Jemena Services 2026 - 2031 Regulatory Proposal

# REVIEW OF ASPECTS OF PROPOSED NETWORK RELATED EXPENDITURES

Report prepared for:  
AUSTRALIAN ENERGY  
REGULATOR (AER)  
August 2025

Figure 2.1: Works program (SCS, ACS and opex) capacity versus demand expressed in hours

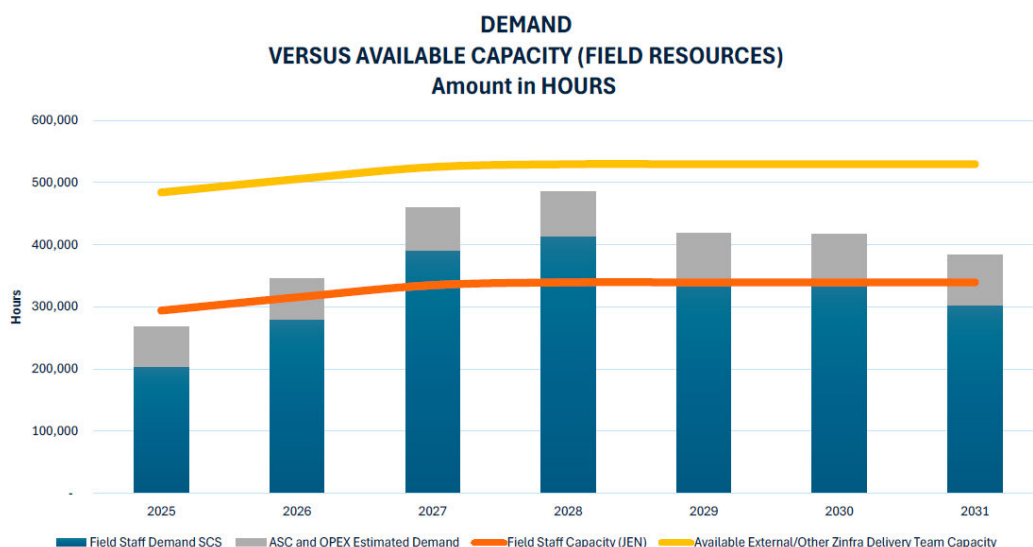
131. As shown in Figure 2.1, Jemena presents a base level of capacity to undertake the forecast works program, and an assessment that the works program will exceed capacity by a reasonable margin. However, Jemena expects to deliver the works program by drawing on its service providers, including Zinfra for peak work, and which exceeds the required capacity.

Figure 3.1: Jemena proposed repex compared with current and historical - \$m, real FY2026<sup>26</sup>

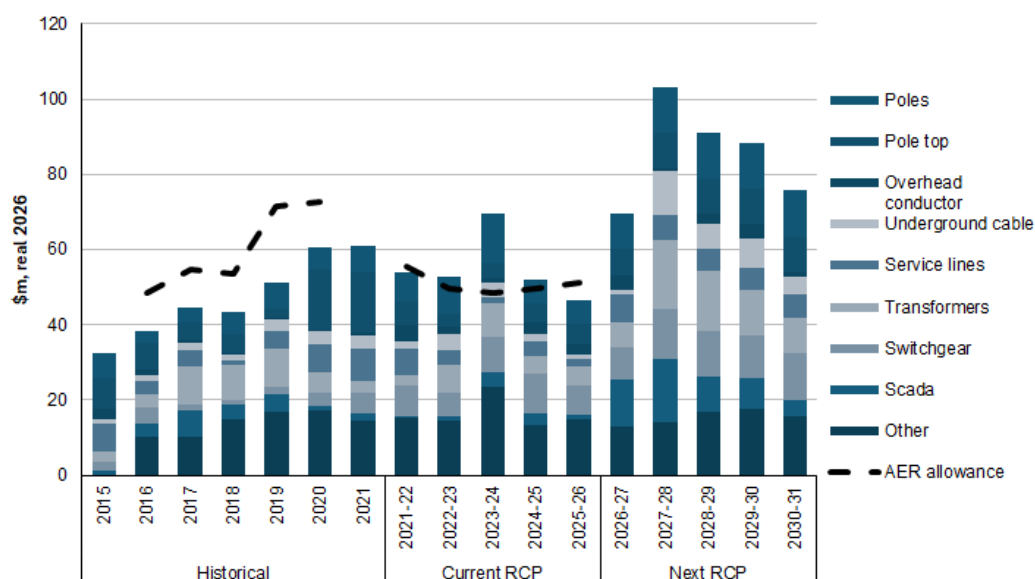
151. In Figure 3.1, we show the historical and forecast repex by RIN asset group reported in the RIN. We also include the AER repex allowance excluding approved cost-pass through amounts.

Figure 3.2: Comparison of average annual repex across regulatory periods - \$m, real FY2026

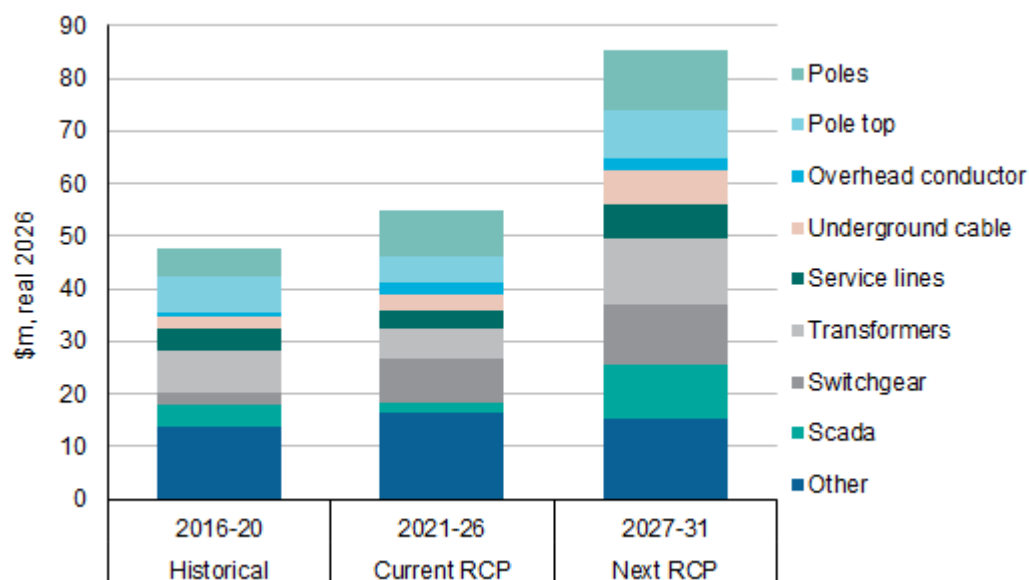
152. In Figure 3.2 we show the average annual repex by asset group for the last three five-year periods. We observe that the annual average repex has been steadily increasing over this period, with the largest increase proposed for the next RCP of approximately \$30 million per year, spread across multiple asset groups.

Figure 3.3: Historical and forecast Pole intervention repex - \$m FY2026

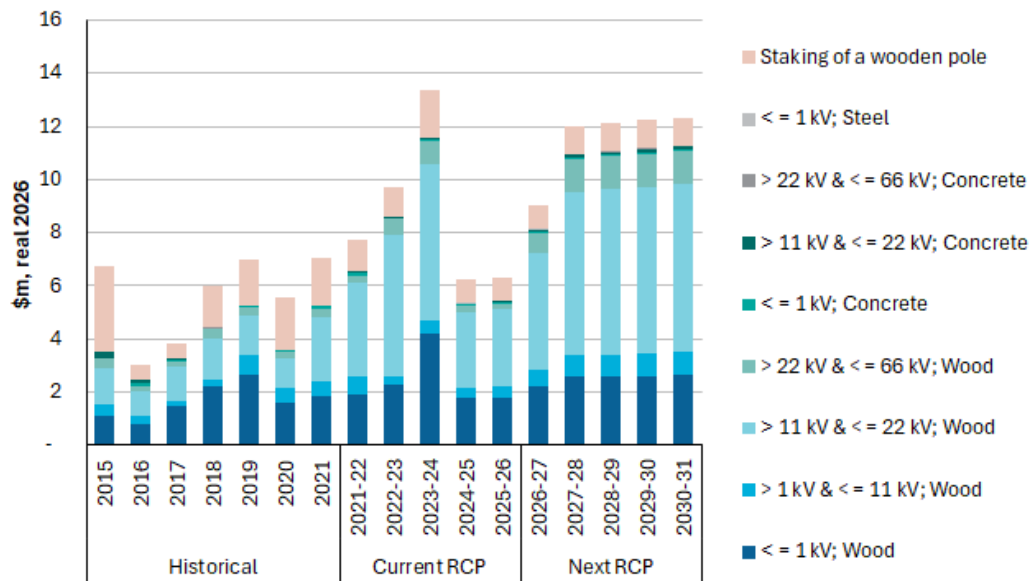
161. Based on our analysis of RIN data, the proposed repex in the next RCP represents an increase of approximately \$14.4 million over the current RCP. In Figure 3.3, we observe an increasing trend in expenditure to 2023-24, before forecast reductions in the final two years of the current RCP. We have not been provided with an explanation for the reduced pole intervention repex in the final two years of the current period.
162. The expenditure profile aligns with the volume of interventions shown in Figure 3.4 and which is the key driver of the proposed increase in the next RCP.

Figure 3.6: Comparison of forecast and historical pole staking rate

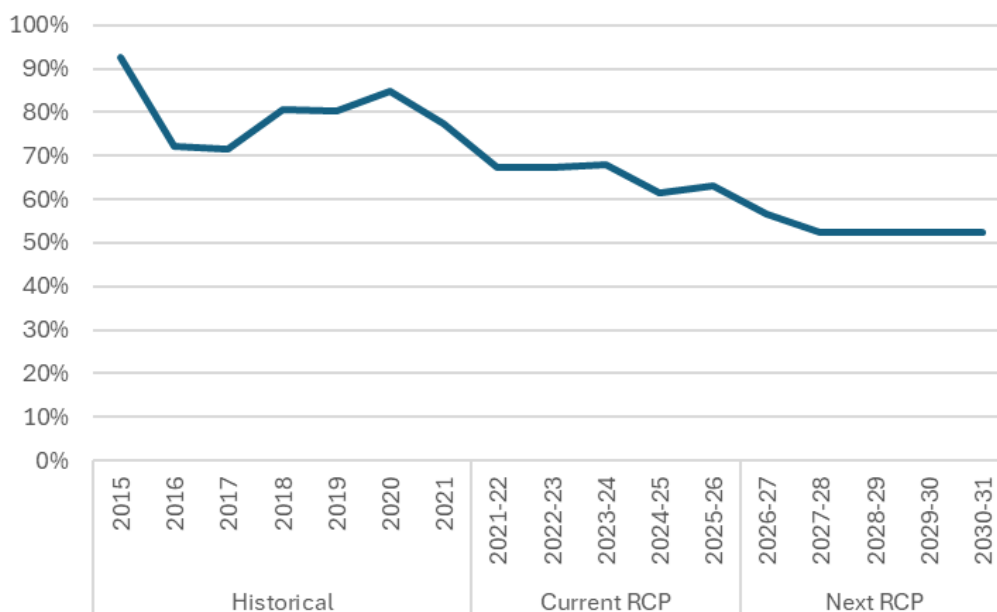
174. We also observe this in a slight reduction to the proposed staking rate, as indicated in Figure 3.6. This trend appears to be directionally consistent with comments made by

Jemena that its experience has been that a higher number of small diameter poles and already staked poles require replacement as they cannot be re-staked.

Figure 3.7: Number of in-service pole failures

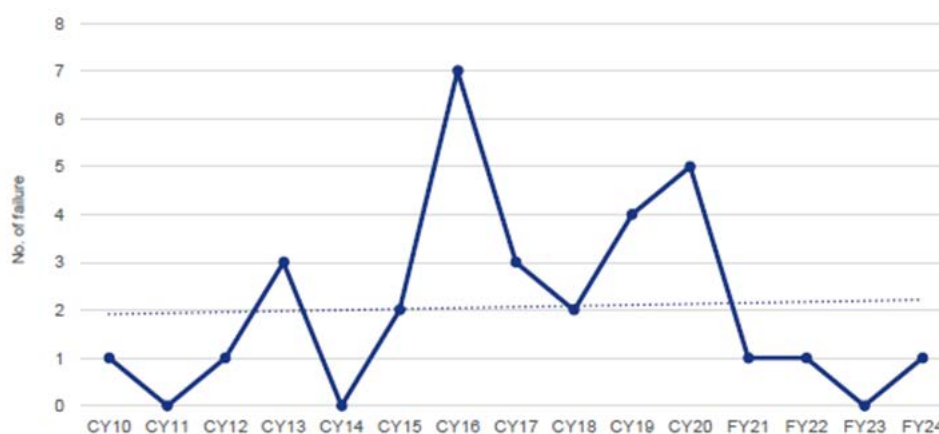
176. We reviewed the asset class strategy for drivers of a potential increase in pole interventions and found that the number of asset failures was flat over the long term, and decreasing over the last five years.

Figure 3.10: Historical and forecast transformer repex - \$m, real FY2026

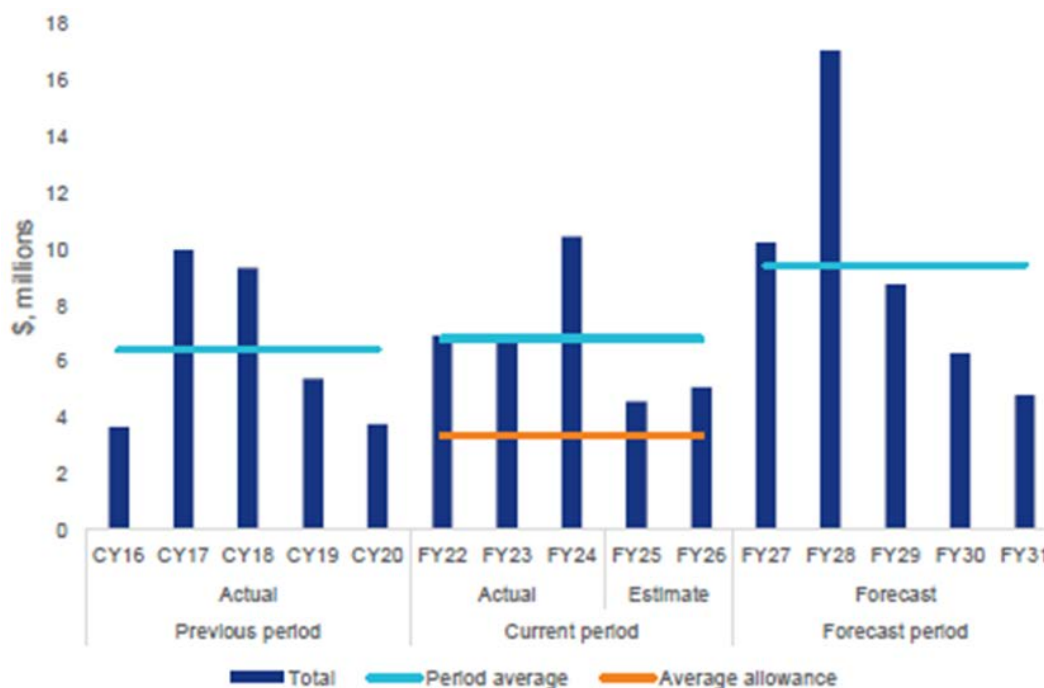
208. We observe an increase in transformer repex for pole-mounted and ground-mounted transformers.
209. In its capital expenditure attachment,<sup>40</sup> Jemena states that historically, it has been spending \$6M - \$7M p.a. on average for the replacement of substation and distribution transformers. This is based on its calculation of an average across the current RCP including estimated repex for the remaining years. The profile relied upon by Jemena in generating this figure is shown in Figure 3.9 and does not align with the RIN data.

Figure 3.12: Historical and forecast SCADA, network control and protection repex \$m FY2026

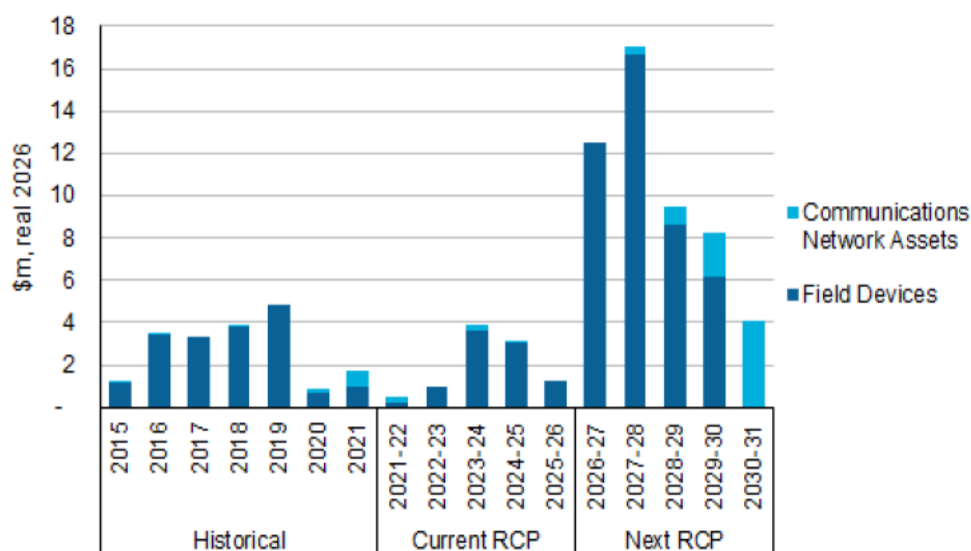
296. Jemena has proposed a significant increase from the estimated repex in the current RCP. Jemena states that the inclusion of major substation rebuild projects of CN and CS and NH are the drivers of the increase, and had these projects been excluded the total would be lower than the expenditure incurred in the current RCP. In Figure 3.13 we show Jemena's

Figure 4.1: Jemena augex by driver - \$m, real 2026

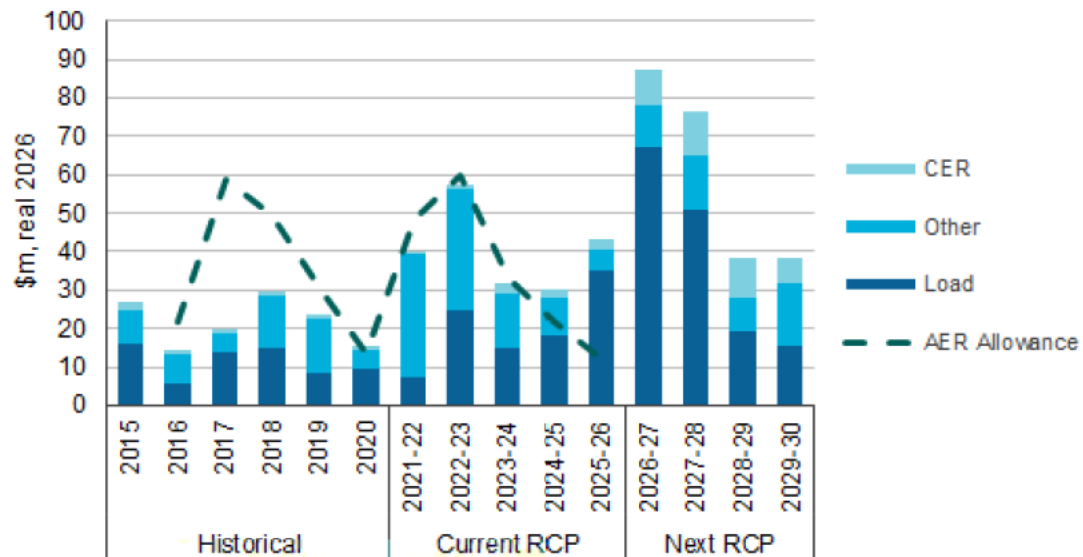
345. Figure 4.1 shows that there is a material uplift in demand-driven augex over the next RCP, and with more expenditure on CER related activities proposed. Jemena expects peak demand over the next 10 years to double and given that it advises that it already has a

heavily utilised network, this is responsible for the step increase in load-driven investment proposed. New data centres are cited as a source of significant strain on the network, for example. Jemena states that it is not forecasting material expenditure in the next RCP to respond to the electrification of transport and gas, relying instead on its CER Strategy and innovation fund to make the best use of its existing network.<sup>66</sup>

Figure 4.4: Northern growth corridor - HV feeder utilisation – 50% PoE

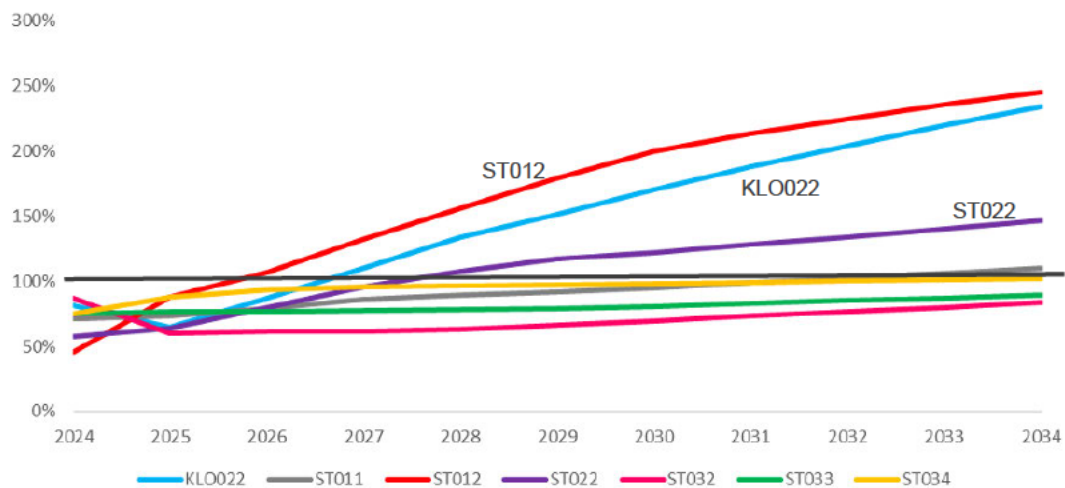
353. As shown in Figure 4.4, Jemena's load forecasts also show that three 22kV feeders will also be overloaded in the next RCP under 50%PoE demand forecast.<sup>72</sup> In the wider Northern Growth Corridor there are another five 22kV feeders that are expected to be overloaded under 10% PoE conditions within the next RCP, including ST011 (in 2031) and ST034 (in 2028).

Figure 4.6: SBY and SHM demand forecast vs N and N-1 ratings

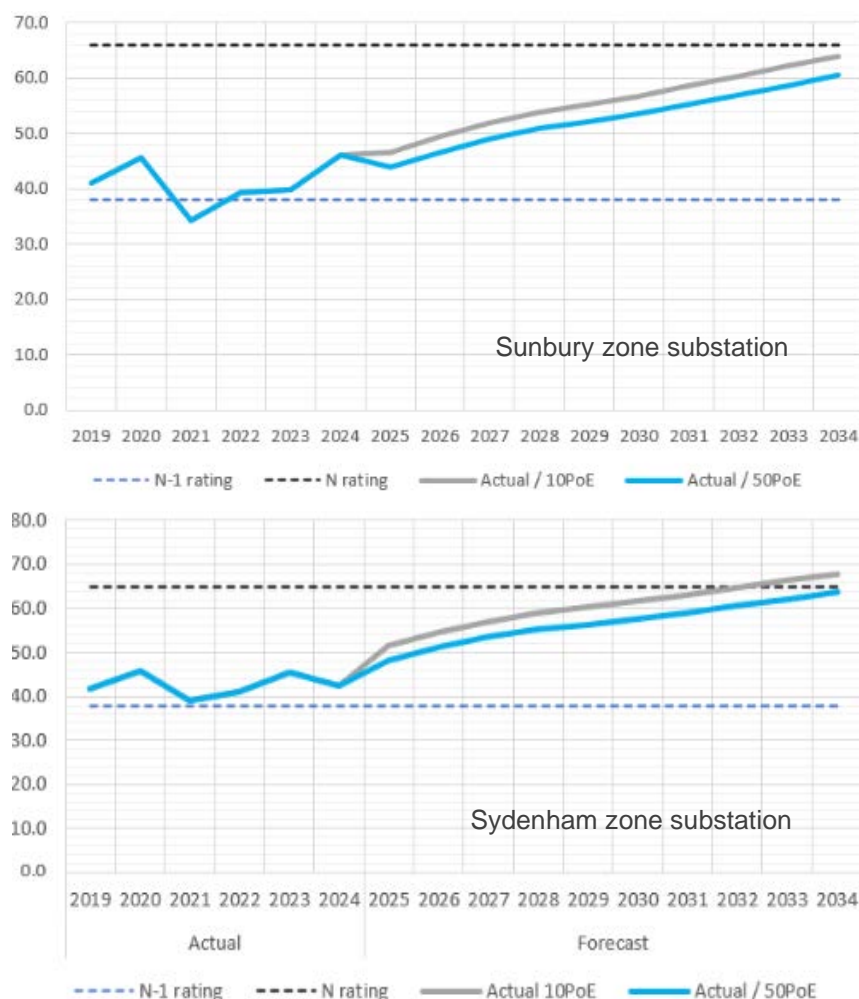
376. Jemena reports that maximum demand for the supply area is expected to grow on average by 3.8% per annum during the next 10-year period (2025-34).<sup>81</sup> Two zone substations, Sydenham (SHM) and Sunbury (SBY) are loaded above their respective N-1 capacities, as shown in Figure 4.6. Whilst the N capacity is not expected to be exceeded in the next RCP,

both substations would be overloaded during worst-case single contingency events with a growing margin.<sup>82</sup>

Figure 4.7: Forecast 10PoE demand versus rating – two 22kV feeders

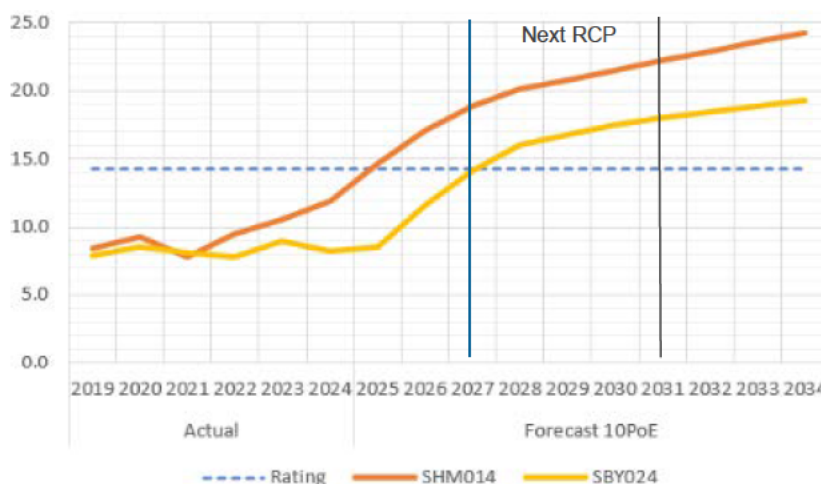
377. A number of 22kV feeders from SBY and SHM are also forecast to be overloaded during the next RCP. Figure 4.7 shows the actual and forecast PoE10 demand versus the continuous rating for two of the more critical feeders in the context of the concentration of expected residential (and other) developments in the corridor. By the start of the next RCP, SHM014 will be 32% overloaded at the forecast peak demand and SBY024 will be about to exceed the line's thermal rating.<sup>83</sup>

Figure 4.8: Years of deferral of SBY-031 feeder with varying VCR (100% = \$47,905/MWh)

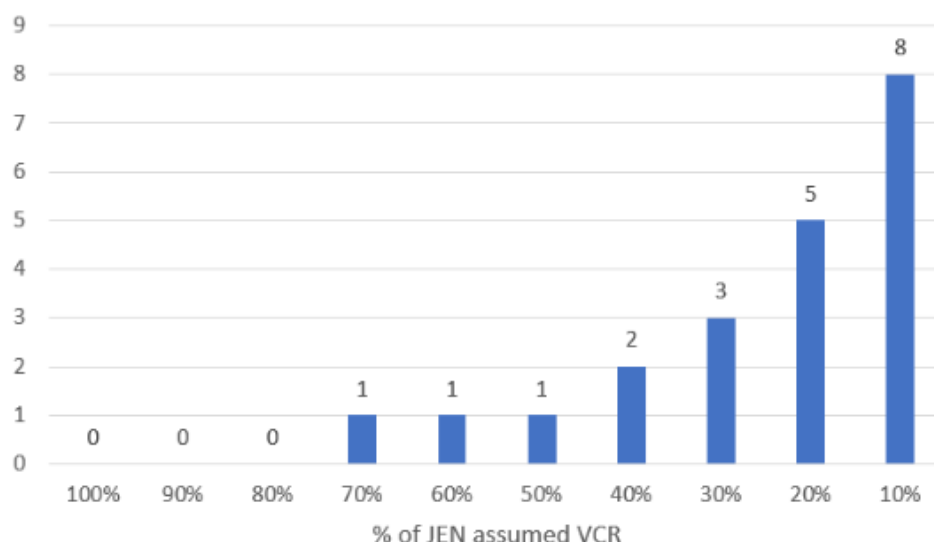
392. As discussed in section 2.4.4, Jemena assumes a VCR of \$47,905/MWh in monetising the EUE and which does not appear to recognise the different VCRs for different customer segments, nor does it reflect the latest AER VCRs for those segments.
393. We sought to overcome these limitations by looking at the sensitivity of the optimal timing to lower (weighted) VCR over a wider range than Jemena's -10% study. This was possible from Jemena's CBA model.
394. Figure 4.8 shows the deferral of the optimum timing from the base case of 2027 with progressively lower VCR. Our conclusions are that (i) the VCR would need to be about 25% or lower than assumed to defer the SBY31 feeder until the next RCP, all other things being equal, and (ii) the optimal timing is not very sensitive to the VCR for this project given the MWh quanta of the feeder overloads.

Figure 4.10: Jemena's economically optimum timing for preferred Option 2

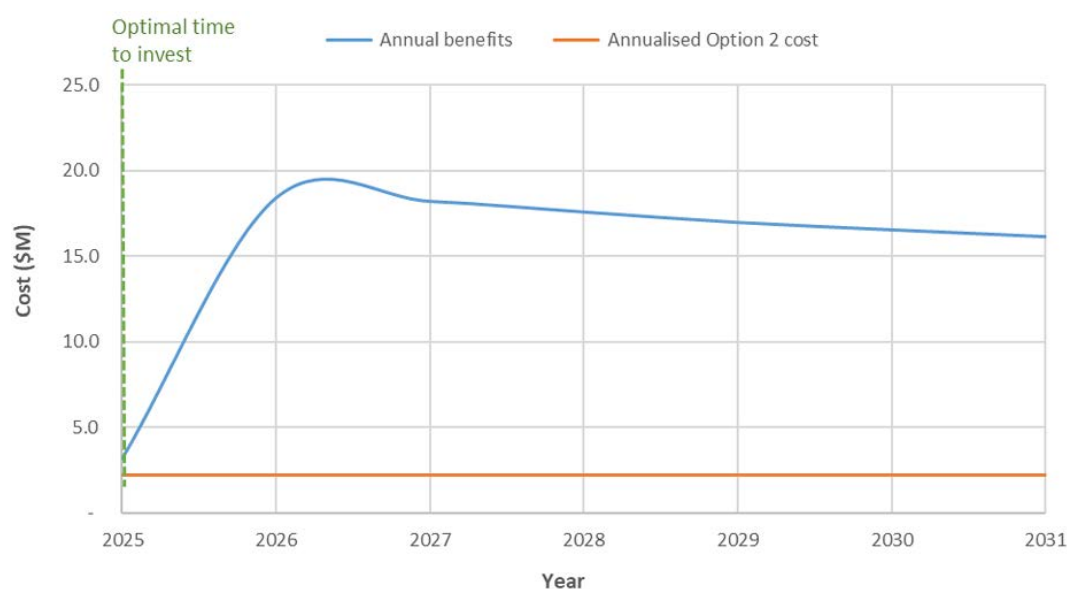
419. Figure 4.10 illustrates that the economically optimum timing with Jemena's base case assumptions is 'now' or, pragmatically, as soon as possible. Jemena's conclusion is reasonably stated as:<sup>102</sup>

*'the proposed remaining program provides the most optimal mix of maximum expected annual benefits (\$3.2M) and the lowest annualised costs (\$2.2M) and, therefore, any deferral of the project will erode the annualised net benefit by at a minimum of (\$1.0M) to JEN's customers for the first year the project is delayed and increasing to (\$13.9M) by 2031.'*
